## **Access Compliance Report Public Rights-of-Way** (Curb Ramps)

Intersection ID: 31692 Main Street: JAKOBSON DR Cross Street: PHIL ONEIL DR Location: NW **Overall Compliance: No Severity Score:** 10 **ADA ID: C49D9B5624ED** Ramp Type: BlendTrans1 Initial Pass/Fail: Fail

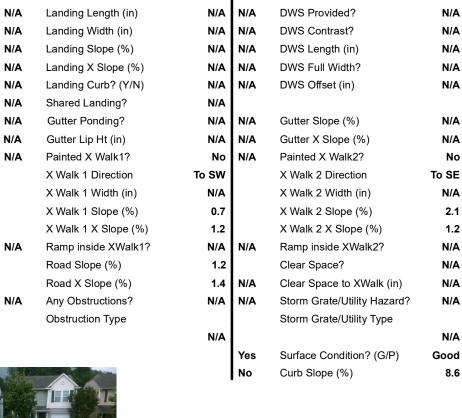
Street 1 Name Stop Condition-Street 1 Street 2 Name Stop Condition-Street 2 **JAKOBSON DR** StopSign **PHIL ONEIL DR** None Possible Solutions: Remove & Replace Curb Ramp With Two New Directional Ramps or Equivalent. Surveyor Notes: N/A PROW/ADA: Not Found, R304.5.1, R304.5.3
